The City of Spartanburg Design Review Board

AGENDA

PROJECT/ADDRESS/ TAX IDSpartanburg Hudson Automotive Parking / 400 E Daniel
Morgan Ave / 7-12-06-061.00**PROJECT NUMBER**

The existing Spartanburg Subaru dealership is proposing the addition of an accessory structure to serve as an auto detailing area, along with an expanded 126-space parking lot. The project also includes new landscaping and streetscape enhancements. This application is for Preliminary Review.

I. Signage: *Not Applicable***ADDITIONAL COMMENTS AND SUGGESTIONS FOR BOARD CONSIDERATION**

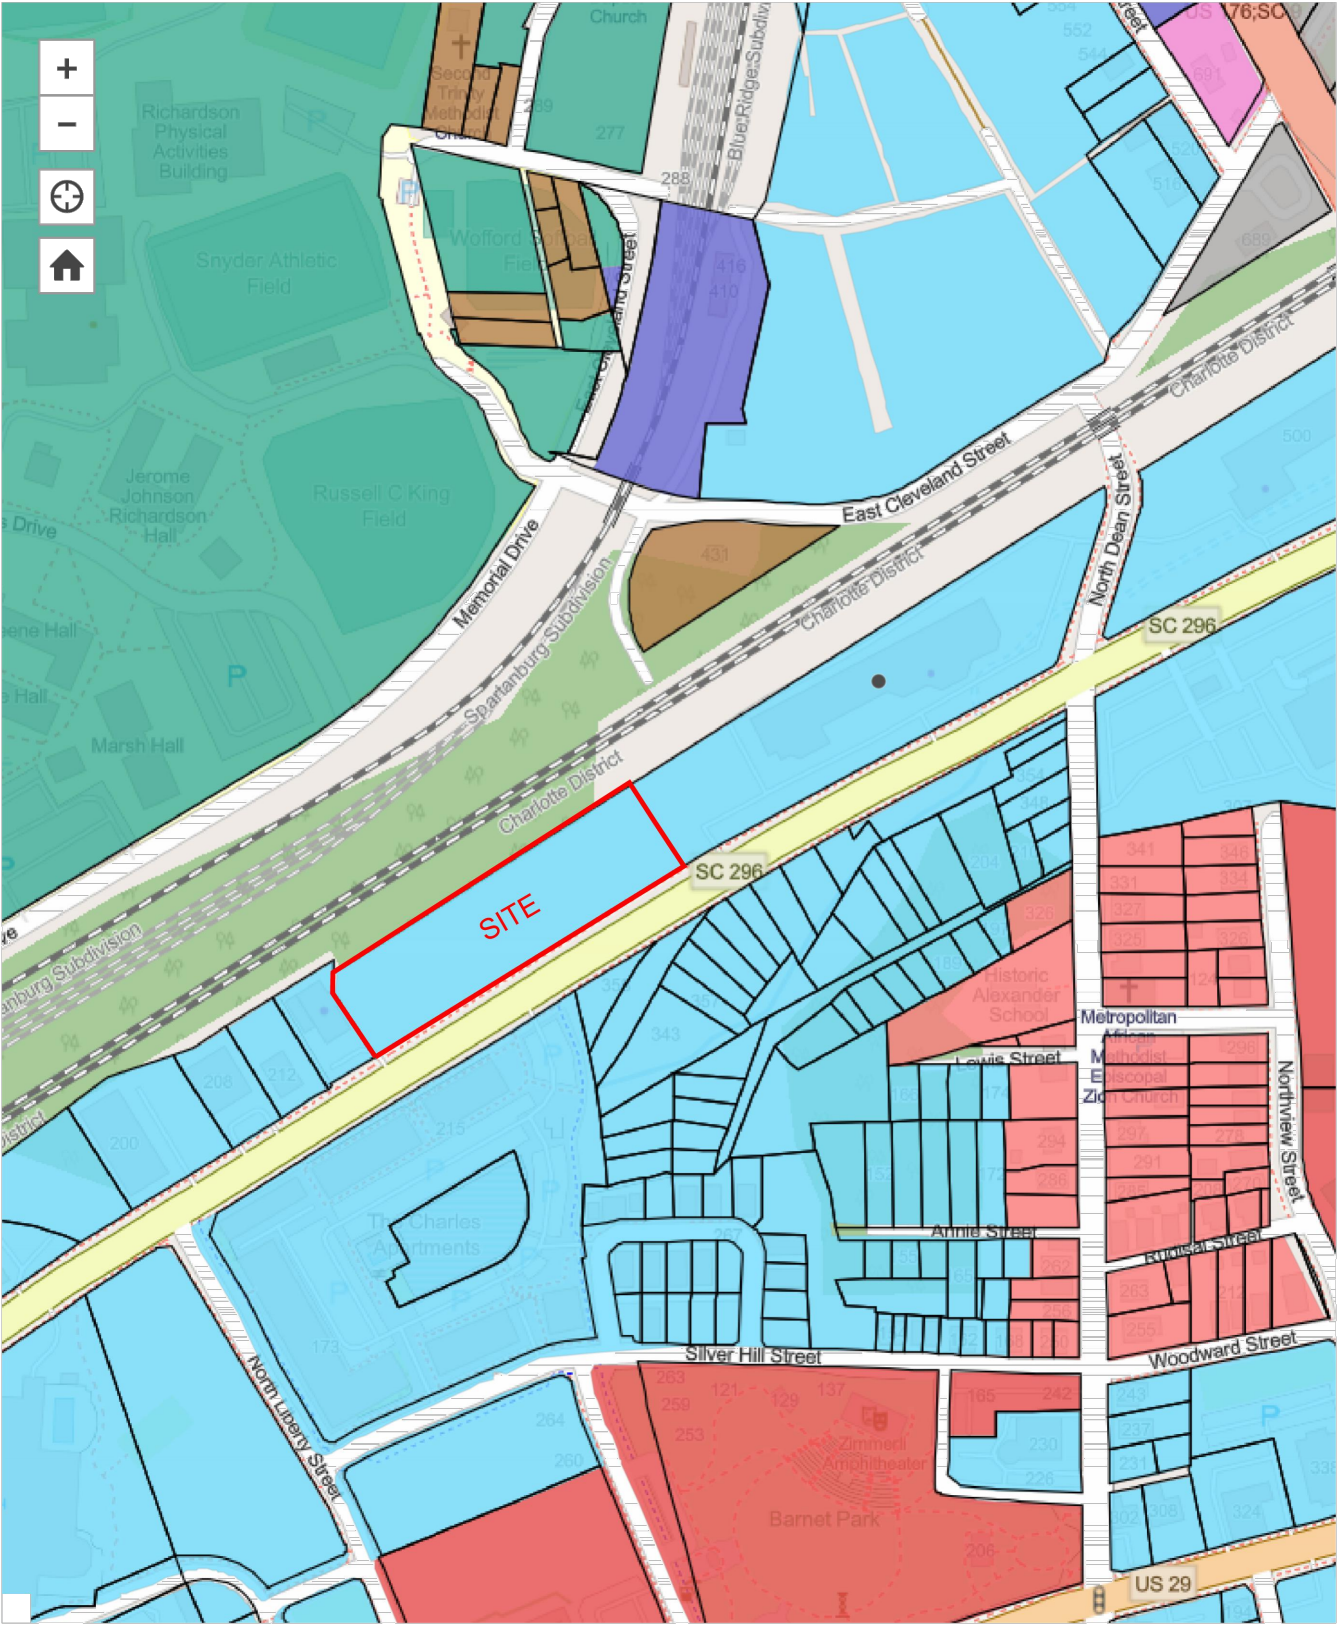
This project is part of a larger automotive corridor enhancement initiative. The proposed landscape and streetscape improvements are consistent with those of the adjacent approved projects, Spartanburg Mazda and Spartanburg Subaru. Exceptions to Streetscape Landscaping and Parking Area Screening were previously granted for these neighboring projects.

SITE PLAN

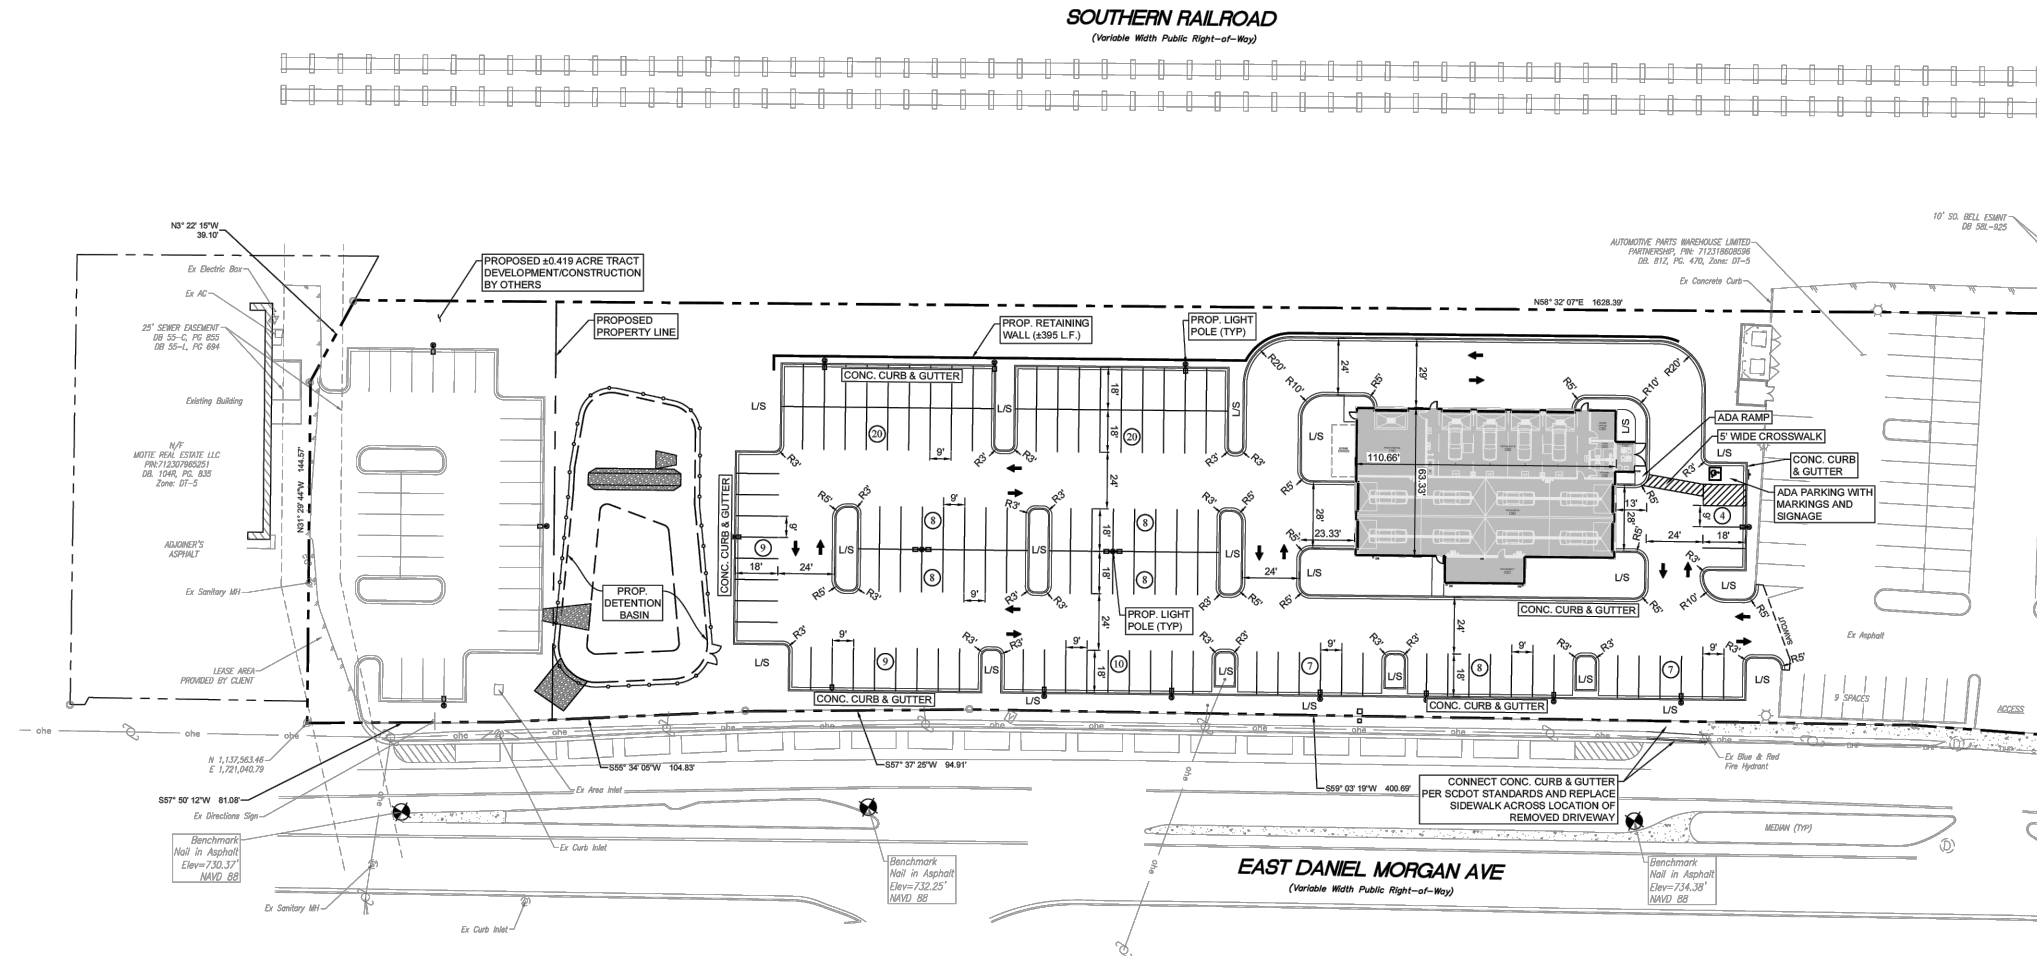
- **8.1 Required Streetscape:**
 - D-T5: 12 ft zone with 8 ft wide sidewalk and trees in wells: *Exception Required – 8ft sidewalk with 14ft streetscape provided; trees are not included. This request is consistent with previously approved treatments for the adjacent Spartanburg Mazda and Spartanburg Subaru projects.*

- No parking space shall be further than 60 feet from the trunk of a canopy tree: *Compliant*
- **8.2.2 Parking Area Screening:** *Exception Required – Shrubs maintained at 2 feet high. Parking areas must have a 3-foot-high screen along the street. This request is consistent with previously approved treatments for the adjacent Spartanburg Mazda and Spartanburg Subaru projects. Landscape screening is also required along the proposed detention pond. It has been added to be compliant.*

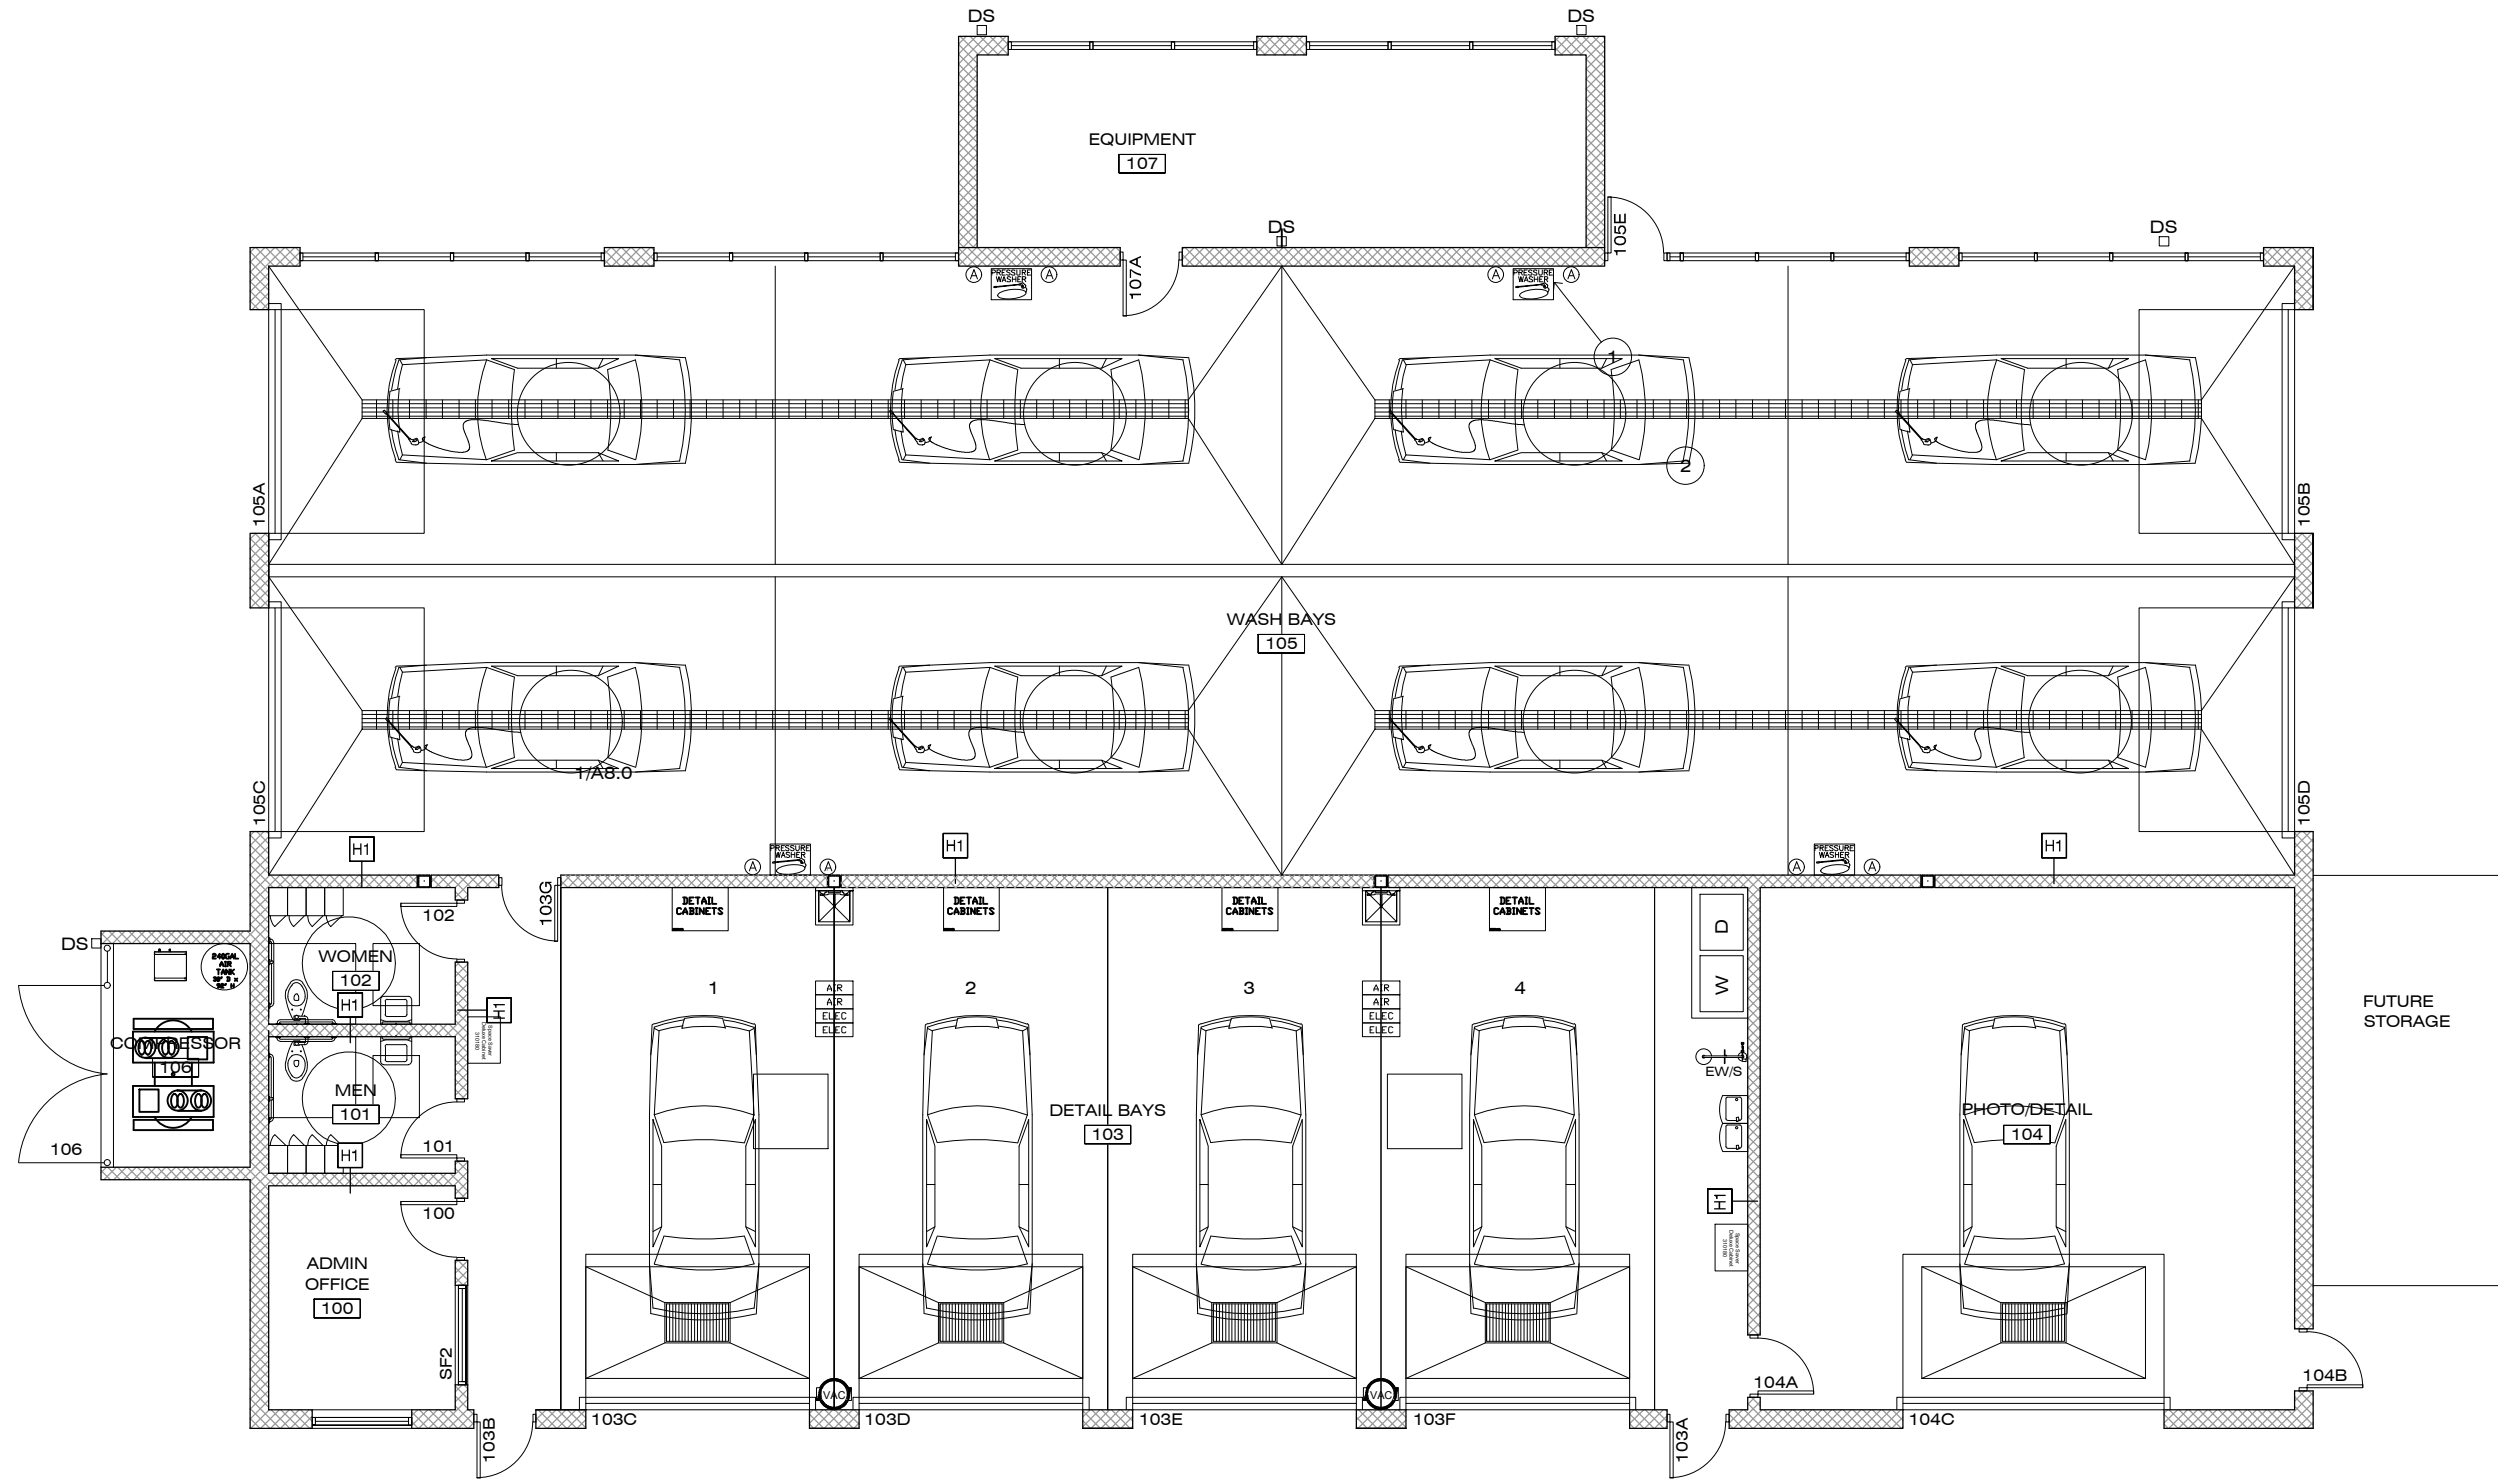
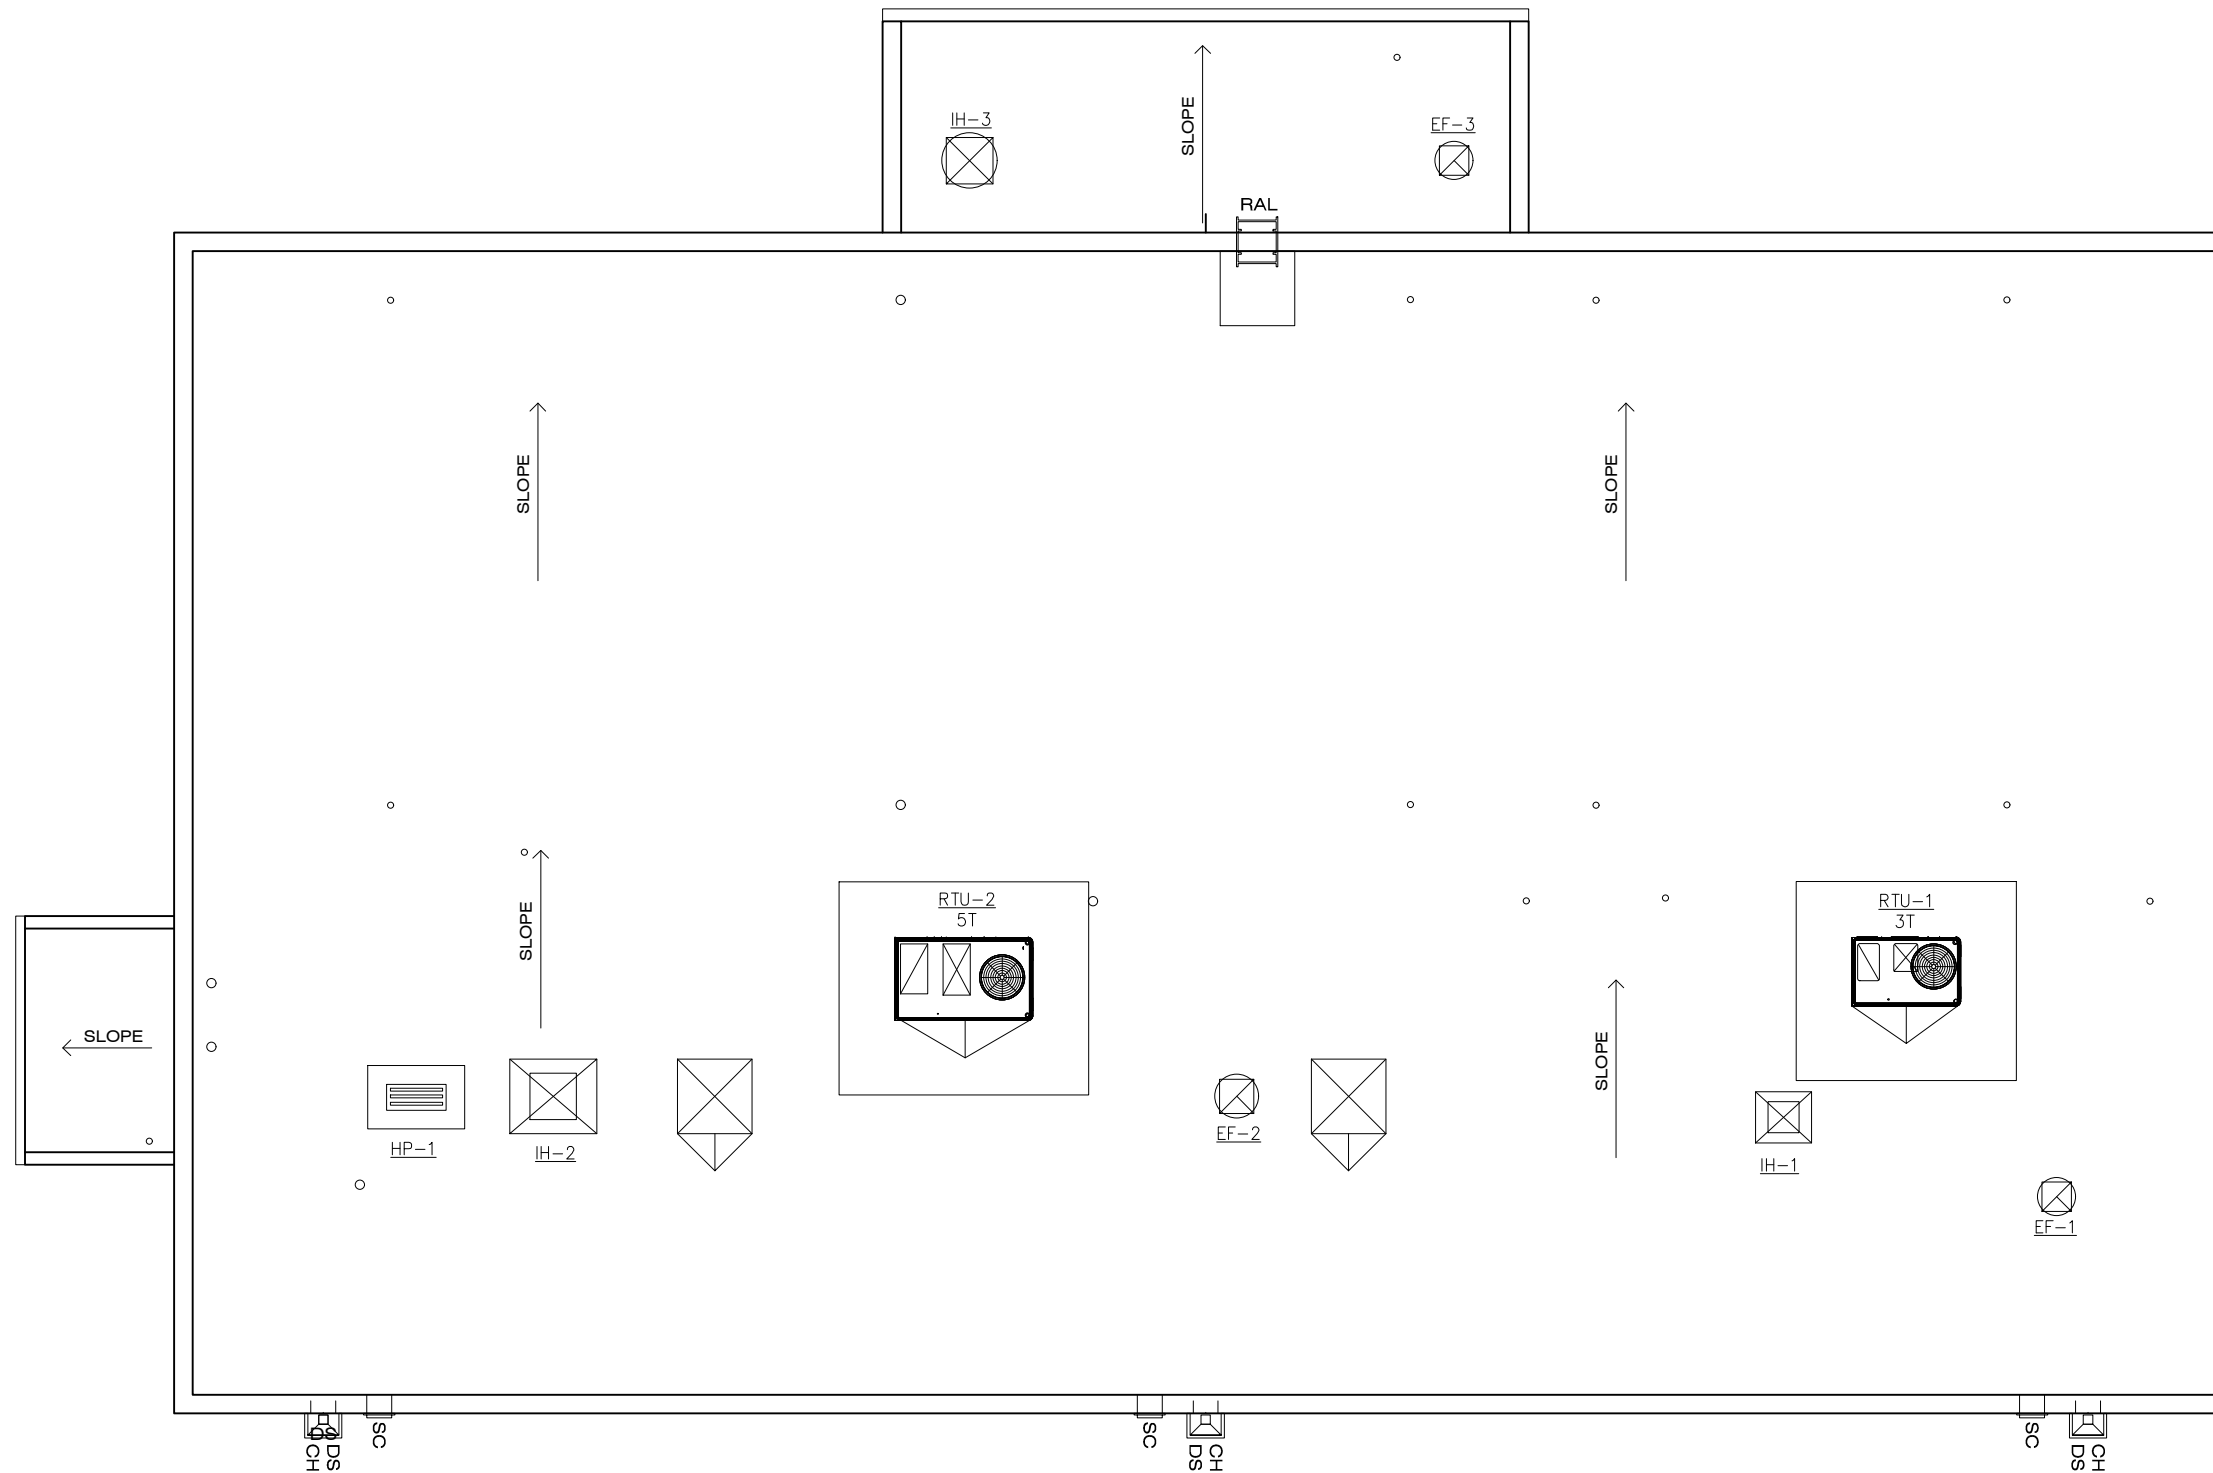
- **6.4.3 Encroachments:** *Not Applicable*
 - **6.4.4 Ground Level Detailing:** *More detail requested – opacity of front facing windows should be in the range of 25-35% to allow sufficient passing of light and movement, but not full transparency into car wash/detail area.*

- **6.4.5 Materials:** *Exception Required – The proposed project uses a metal paneling system to match the adjacent car dealership.*
